HIGHLAND CITY DEVELOPMENT ADMINISTRATION BOARD AGENDA Wednesday, March 11, 2026

DEVELOPMENT ADMINISTRATION BOARD AGENDA REPORT ITEM #2

DATE: March 11, 2026
TO: Development Administration Board
FROM: Rob Patterson, City Attorney / Planning & Zoning Administrator
SUBJECT: Final Plat Approval: Ridgeview Pod B Plat O
TYPE: LAND USE (ADMINISTRATIVE)

RIDGEVIEW POD B PLAT O
HIGHLAND CITY, UT
COVER SHEET

Scale: 1"=30'
 Date: 02/25/26
 Sheet: C4

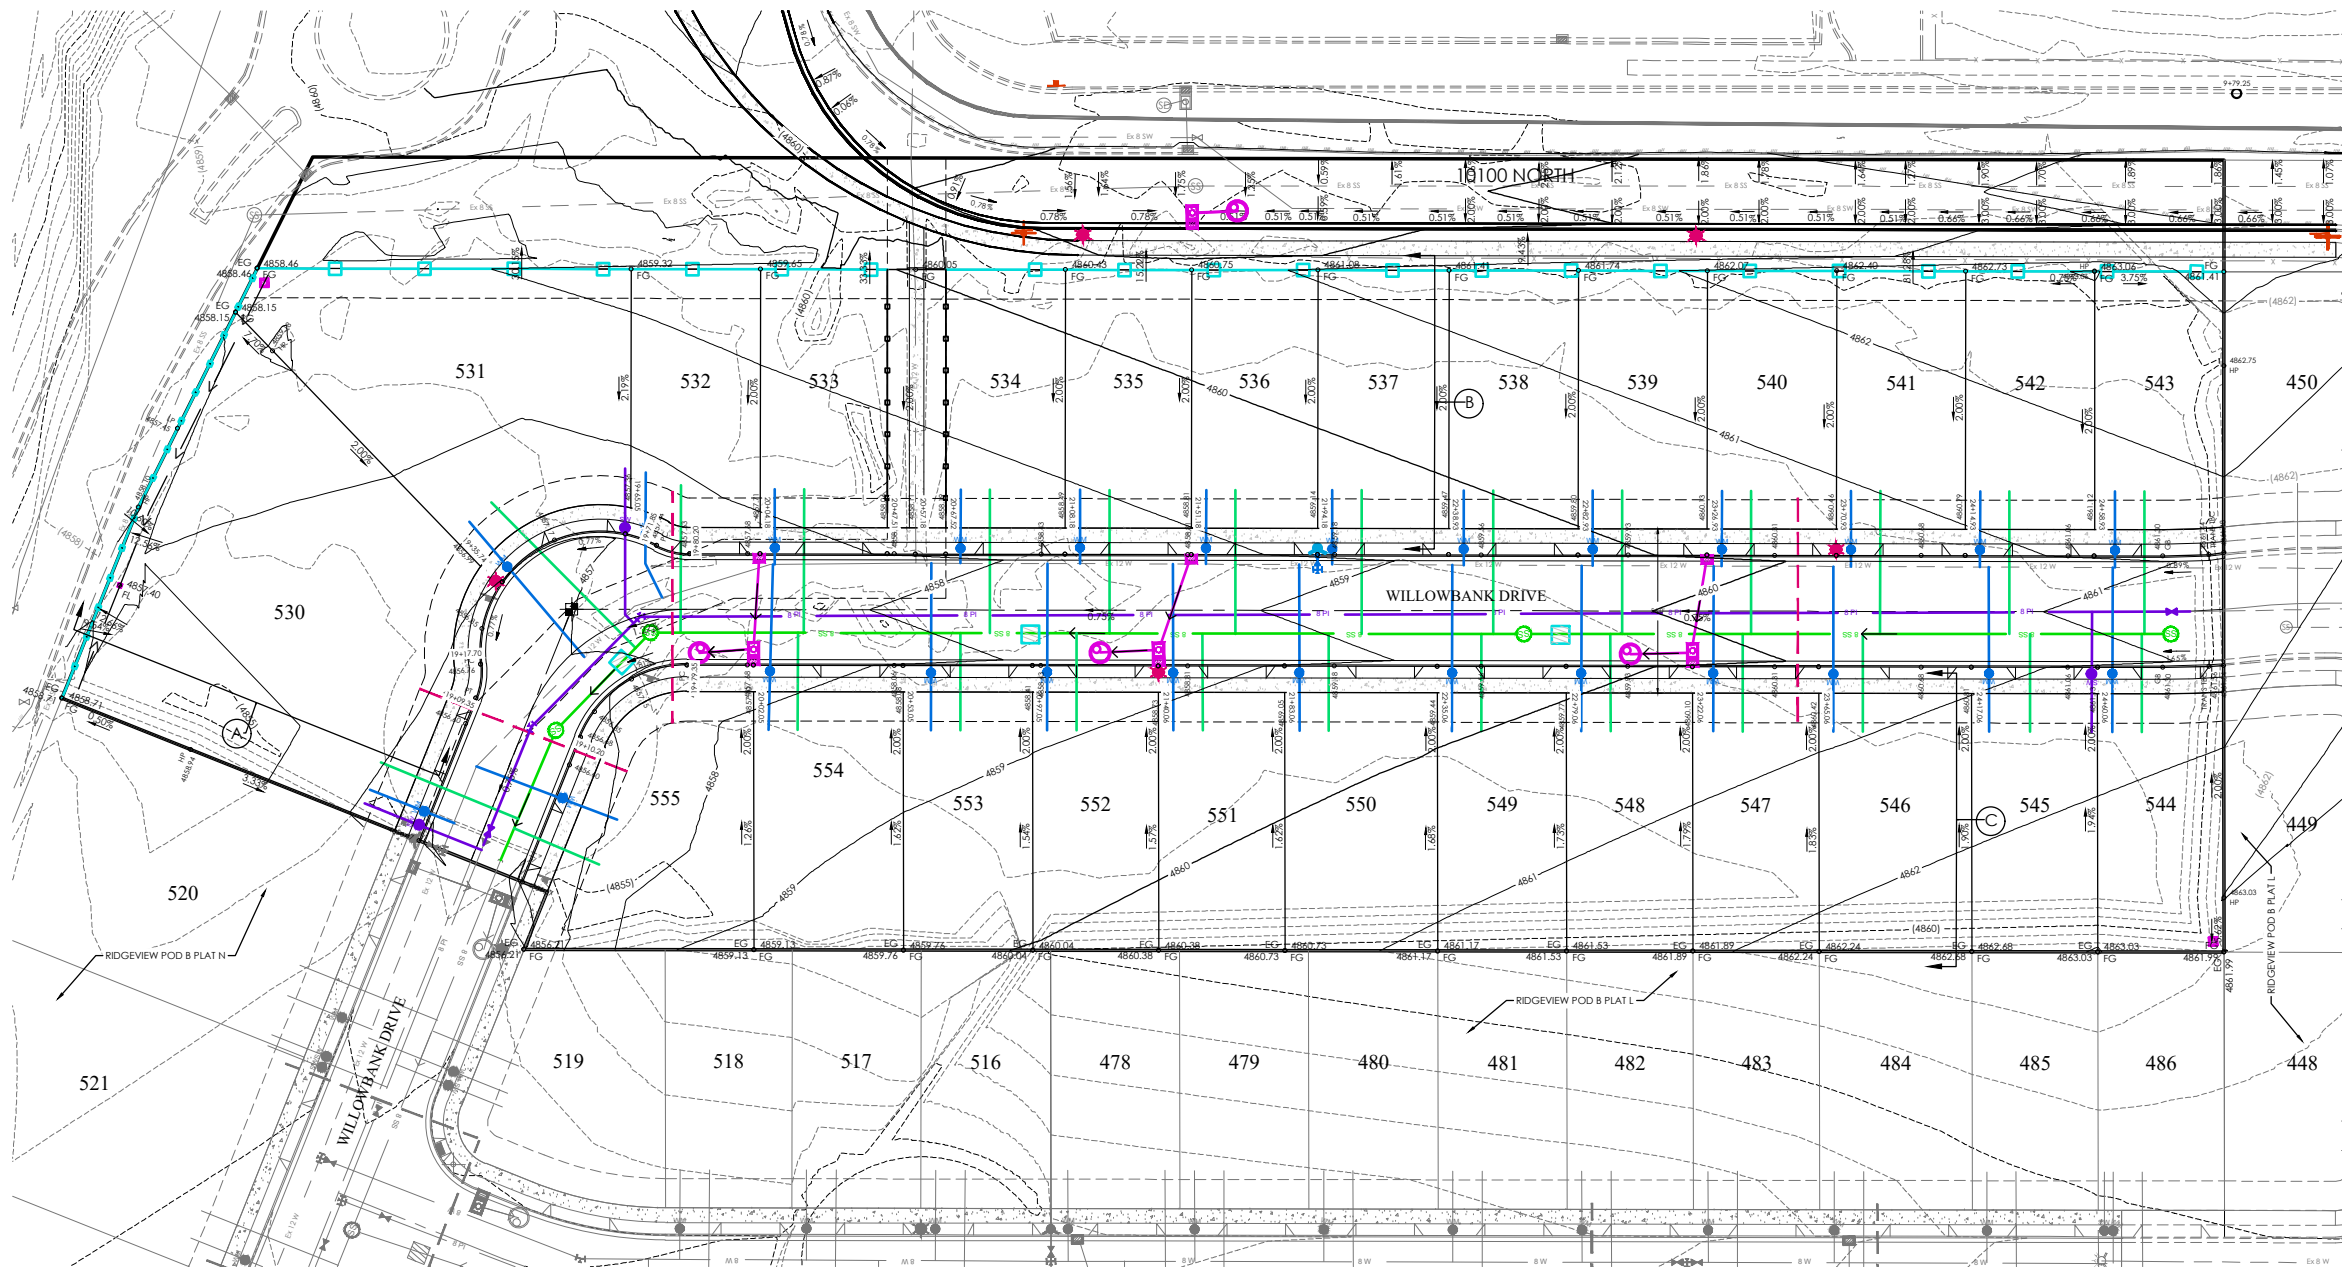
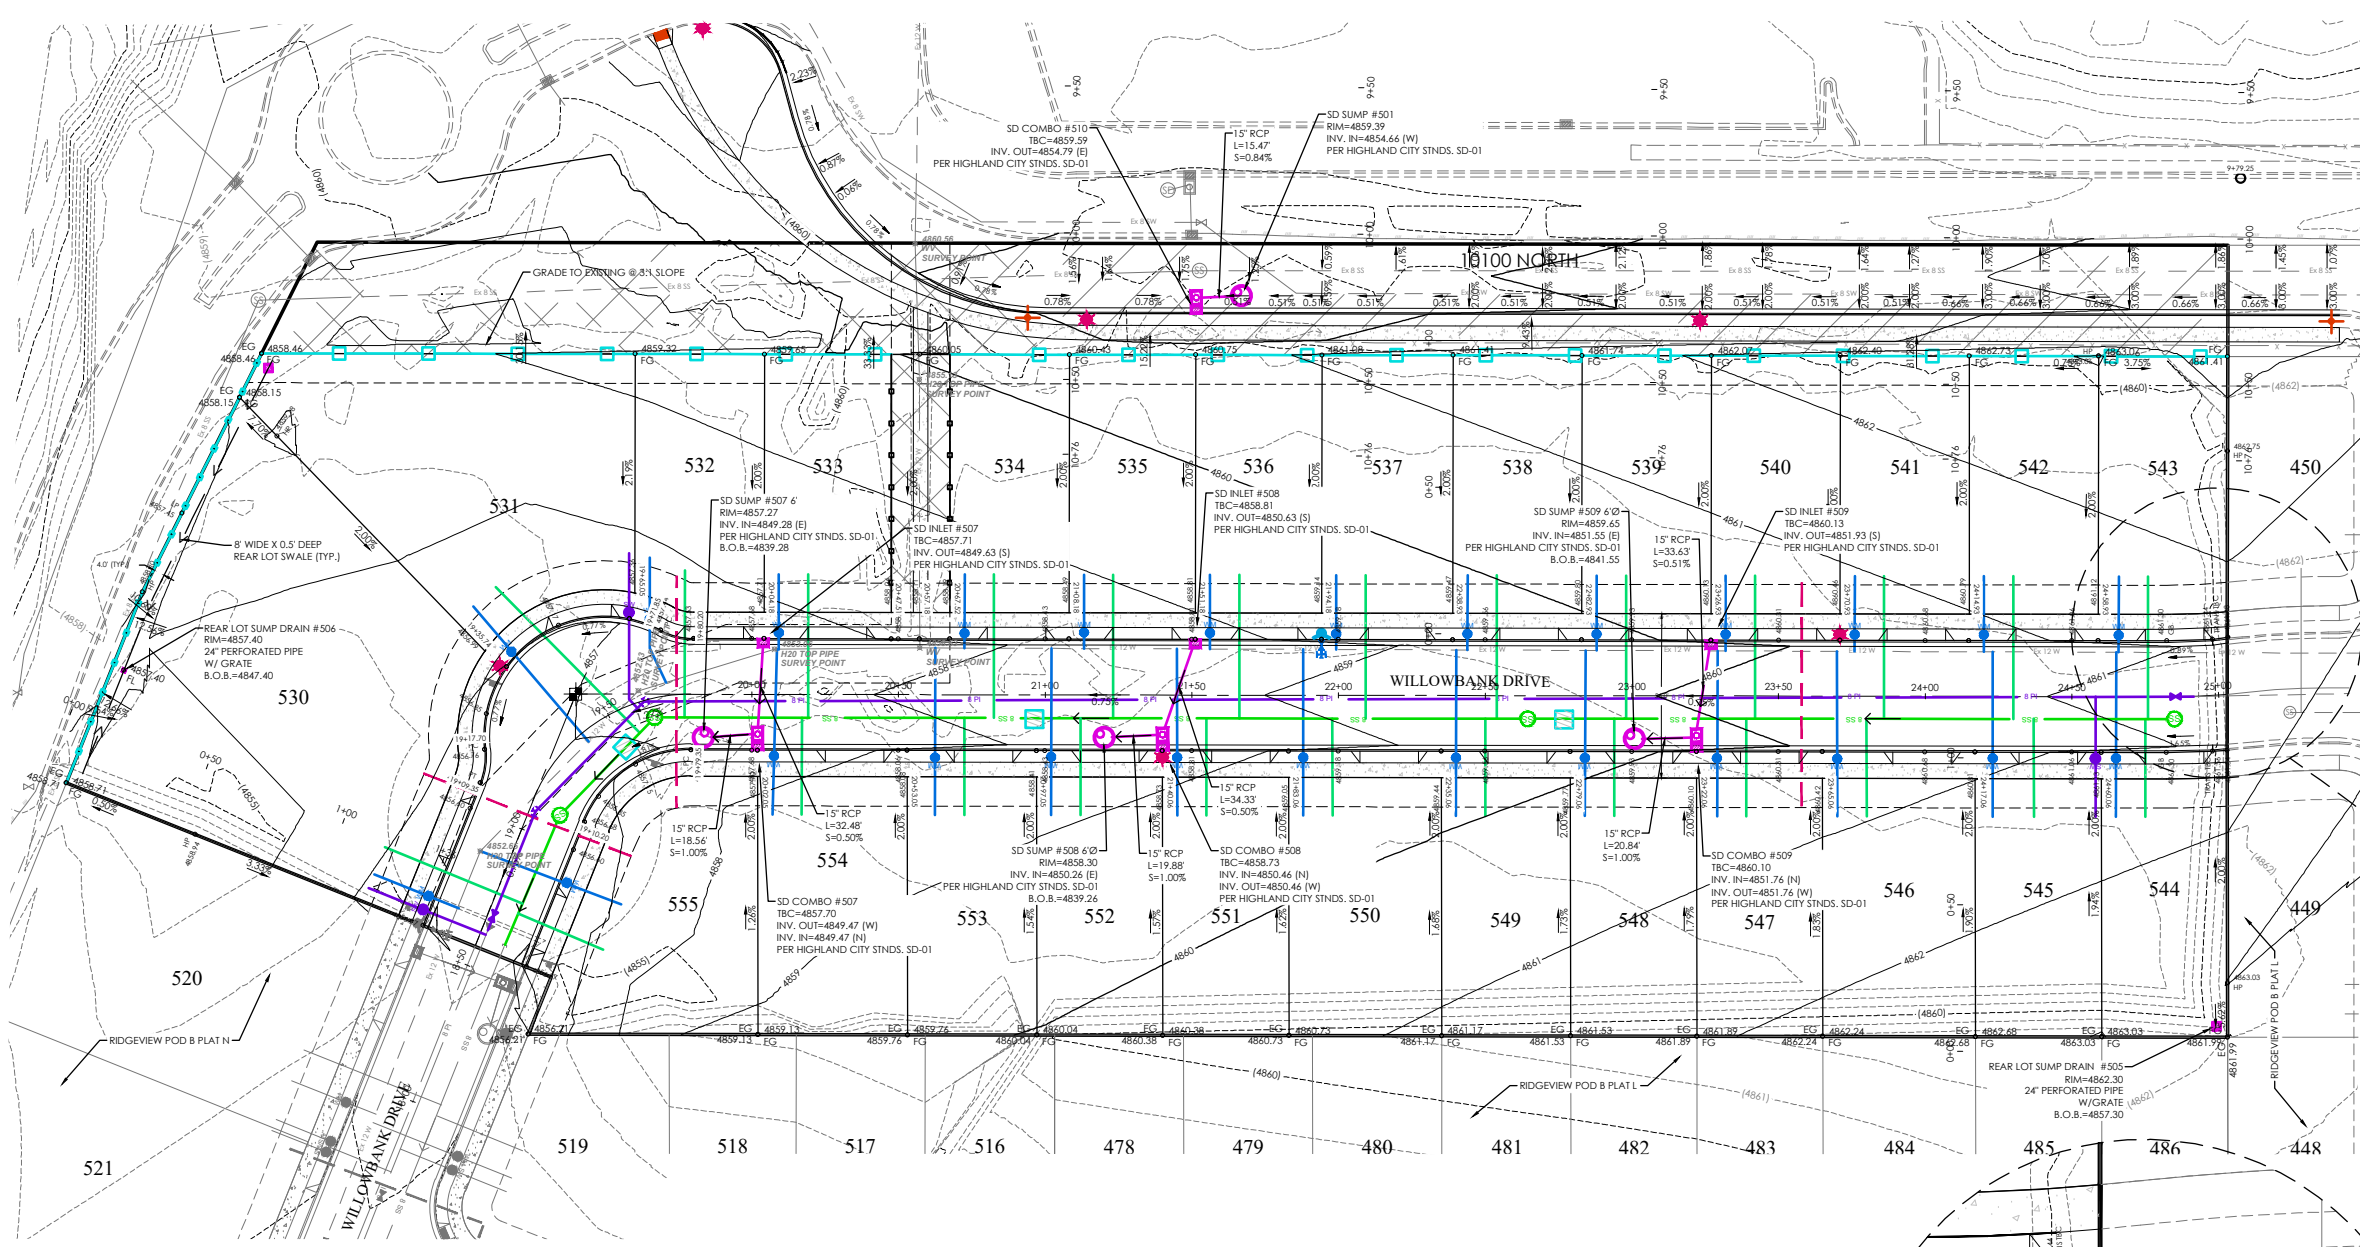
10. Label rear lot sump for lot 531.
11. Provide alternative solution for catch basin inlets being on top of the existing 12" DIP potable waterline.
12. Show and label PI service for lot 555.
13. Sump 501 is not existing. It will be a new sump. The volume of this sump can be adjusted to be what it needs to be based on what happens with 10100 N.
